Subject: VIRGIL C. SUMMER NUCLEAR STATION (VCSNS), UNIT 1
DOCKET NO. 50-395
OPERATING LICENSE NO. NPF-12
RESPONSE TO REQUEST FOR ADDITIONAL INFORMATION
CONCERNING 2012 ANNUAL ECCS EVALUATION MODEL
REVISIONS REPORT

**VIRGIL C. SUMMER NUCLEAR STATION (VCSNS) UNIT 1
DOCKET NO. 50-395
OPERATING LICENSE NO. NPF-12**

**VIRGIL C. SUMMER NUCLEAR STATION, UNIT NO. 1 – RESPONSE TO REQUEST FOR
ADDITIONAL INFORMATION CONCERNING 2012 ANNUAL ECCS EVALUATION MODEL
REVISIONS REPORT (TAC NO. MF2722)**

Figure 1. V. C. Summer Baffle-Barrel Region Downflow Path

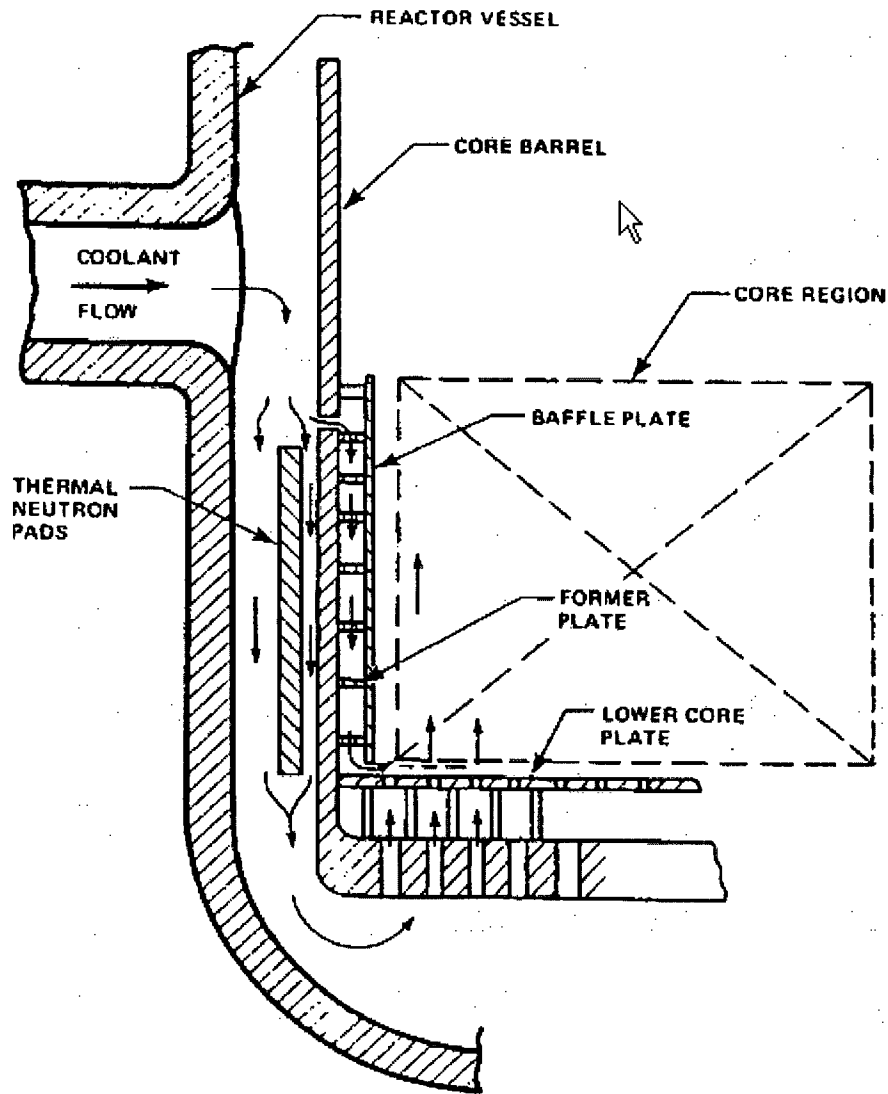
Provide a more detailed description of the upflow conversion and explain its implementation status.

During Cycle 16, V. C. Summer experienced fuel failure because of grid to rod fretting. This failure mechanism was initiated by reactor coolant cross-flow jetting through the joints between baffle plates. The susceptibility to this condition was due in part to the reactor internals flow configuration.

The V. C. Summer reactor vessel lower internals assembly consists of a core barrel into which baffle plates, supported by interconnecting former plates, are installed. The original reactor vessel internals configuration incorporated downward coolant flow in the region between the core barrel and the baffle plates as depicted in Figure 1. Since the flow direction through the baffle-barrel region was opposite to the direction of the flow through the core, there was an axial pressure gradient across the baffle plates, which varies from a maximum at the top of the core

to a minimum at the bottom of the core. This pressure gradient provided the driving force for cross flow jetting through the joints between baffle plates.

In order to substantially reduce the possibility of the baffle jetting, the reactor vessel internals were field modified during Refuel 18 (Fall 2009) to reverse the secondary coolant flow pattern in the baffle-barrel region in order to reduce the jet-driving pressure gradient across the baffle joints. The hardware change for this modification (i.e., Upflow Conversion), consisted of plugging the existing flow holes in the core barrel between the top and second former level and machining new flow holes in the top former plates. These changes resulted in a substantial reduction in the driving force for coolant jetting through the baffle plate joints. Section 4.2.2.2 of the V. C. Summer FSAR contains a brief description of the modification and its impact on the flow pattern within the baffle-barrel region.
